January 18, 2019
Subject: Recall R89910
TO: All U.S. and Canadian Volvo Retailers

**Recall R89910: Tailgate Lift Arms (Drive Units)
Model Year 2018 – 2019 XC60**

Title	Inspection and replacement of "drive units", tailgate lift arms	Page:	1 (5)
Action

Condition 1, OK

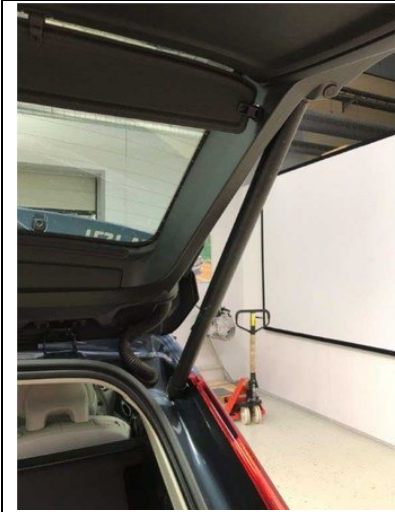
-Condition 1, replace the lifting arms according to VIDA VCC-370949-5.

Condition 1

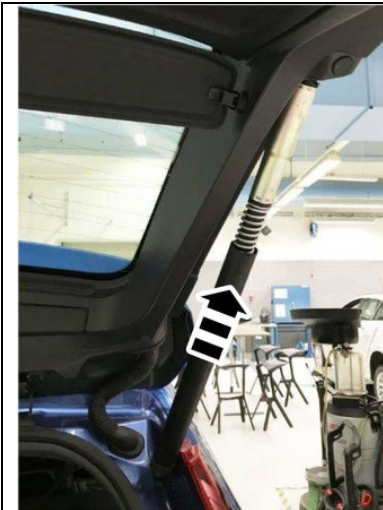
If motor, power operated tailgate looks according to image, both dampers are to be replaced according to Vida:

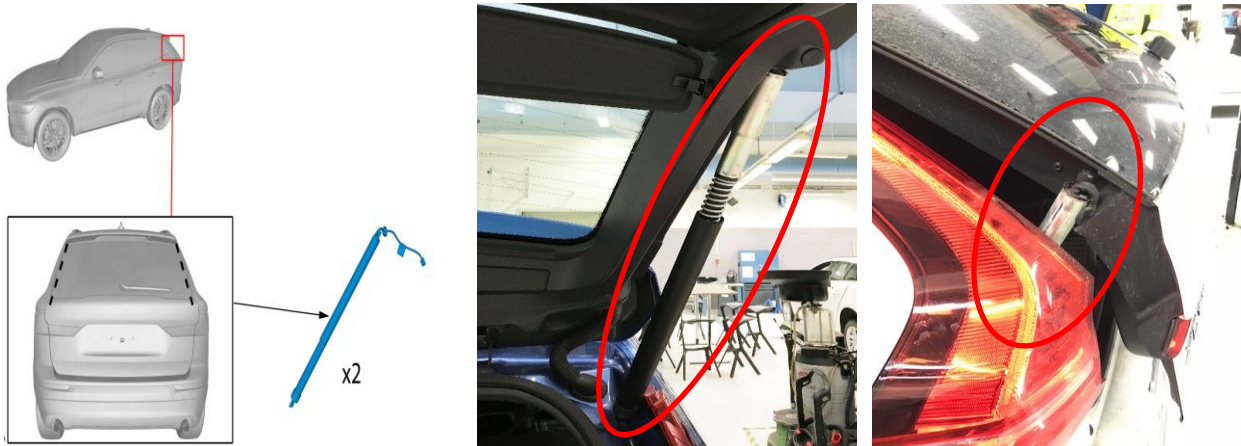
Volvo Cars investigations have identified that the tailgate lifting arms under certain conditions and cold temperatures may freeze. If this would occur, it may lead to noise or loss of function when operating the tailgate in freezing conditions with risk of separation of the tailgate lifting arms.

In certain cases, this may result in complete separation of tailgate lifting arms with spring detaching and projecting in a rearward direction with significant force resulting in risk for personal injury.

The corrective action is replacement of the tailgate lifting arms with an improved design part **at no cost to you**.

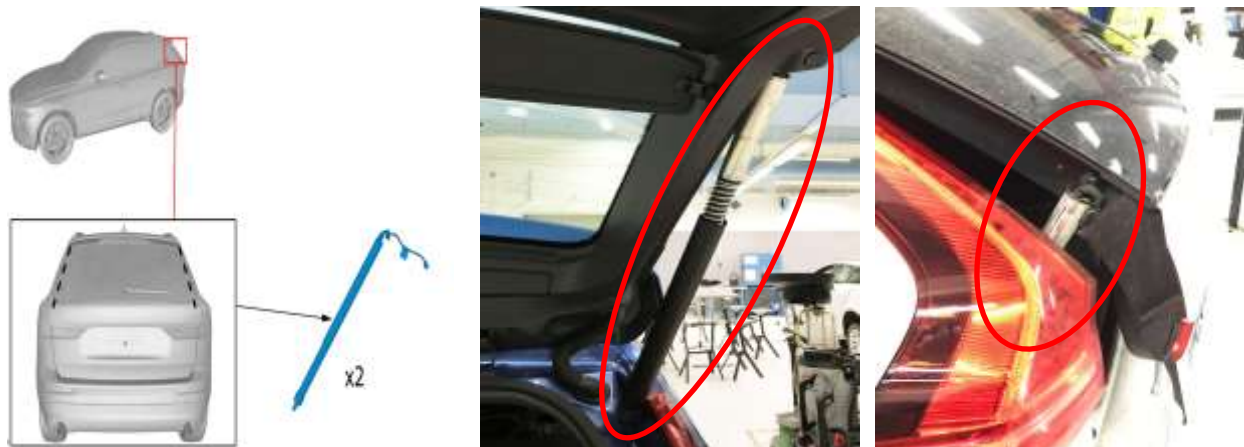
Las investigaciones de Volvo Car identificaron que los brazos de elevación de la compuerta trasera, en ciertas condiciones y con temperaturas frías, pueden congelarse. Si esto ocurriera, podría causar ruidos o pérdida de la función al operar la compuerta trasera en condiciones de frío intenso, con riesgo de que se separen los brazos de elevación de la compuerta trasera.

En ciertos casos, esto puede provocar la separación total de los brazos de elevación de la compuerta trasera, con desprendimiento del resorte y proyección hacia atrás con fuerza considerable, que provoque un riesgo de lesiones personales.

La medida correctiva es el reemplazo de los brazos de elevación de la compuerta trasera, por una pieza con diseño mejorado, **sin costo para usted.**
